Historical Architectural Review Board
COA Preliminary Review Sheet

HDC-2025-00102

Address: 521 N 6th Street

Proposal: Remove and install new decorative paneling around second floor bay window (Violation Correction)

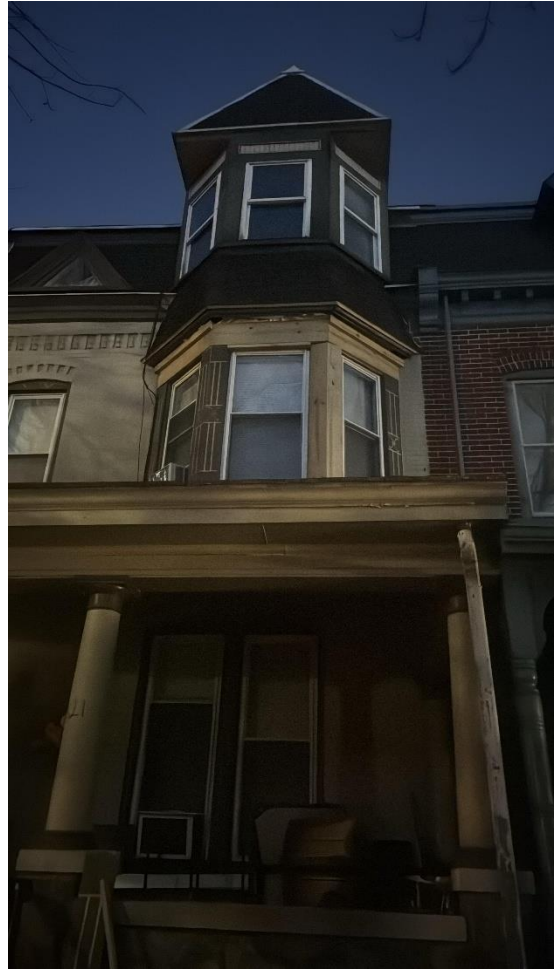
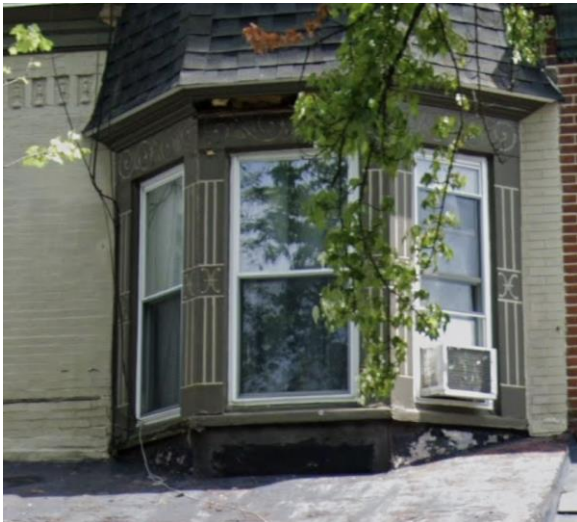
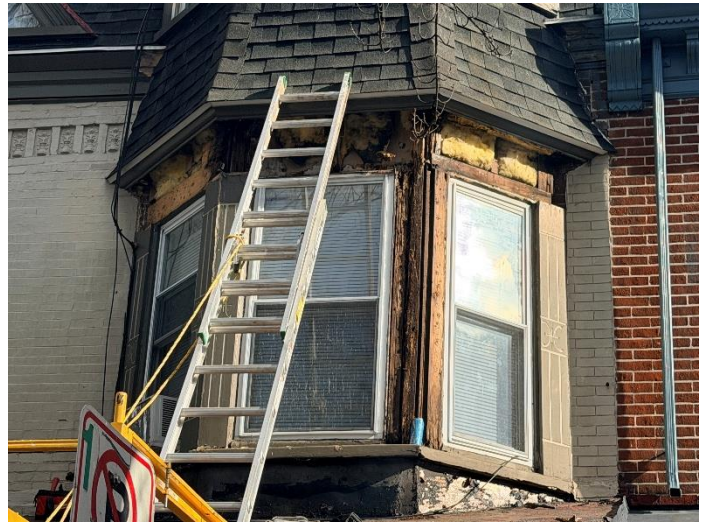
Observations & Comments: The applicant offered a descriptive approach to the treatment of deteriorated wood elements at window panels and soffits. The photographs submitted focus on the second-floor projecting bay window. More information would be helpful to understand the extent of the work area- i.e., confirming that the work only at the second-floor projecting bay window, or if other areas of the façade are included. Generally, it is appropriate for the exterior face of the wood trim to be scribed to match the original wood trim detailing. All wood surfaces should be painted.

The proposed scope calls for adding new scribed trim onto replaced substrate. Based on the submitted photos, it appears that replacement wood is in plane with original scribed trim. More information would be helpful to understand how a consistent finished plane will be achieved; ensuring that edges align appropriately to adjacent elements, such as other trim and window sills.

Staff Recommendation: Staff request more information on the extent of the work area and the approach for achieving a consistent plane of the trim's surface. Generally, the proposed approach to replacing the wood trim is appropriate. All exposed wood surfaces should be painted.

The applicant stated that his company was hired to replace the deteriorated wood panels; many were severely rotted and in poor condition. The rotted wood was removed and replacement wood added to create a sound, weathertight condition. The applicant proposed taking a physical tracing of the original panels as a basis for recreating the trim. The Board discussed a few options for how that could be achieved, such as using a router, a CNC machine, or handcarving. Mr. Hart suggested that the means of creating the panels is up to the contractor; the goal is for the panels to be visually similar to the original ones.

The applicant noted that the new carved piece would be affixed to the new wood framing, and that it would be done in a way to maintain drip edges and continuity. He noted that the wood window sills are existing to remain, and confirmed that the work is only at the second floor bay window.

Mr. Encelewski moved to approve with conditions the application presented on 1/5/2026 for the replacement of window trim panels at 521 N. 6th Street with the following conditions agreed to by the applicant, and found compliance with the following section of the Guidelines for Historic Districts: Chapter 3, Section 3.2 – Wood Siding and Trim and found that there were not circumstances unique to the property:

- Wood trim replacement material would be cedar, cypress, or mahogany. Final material to be submitted to staff
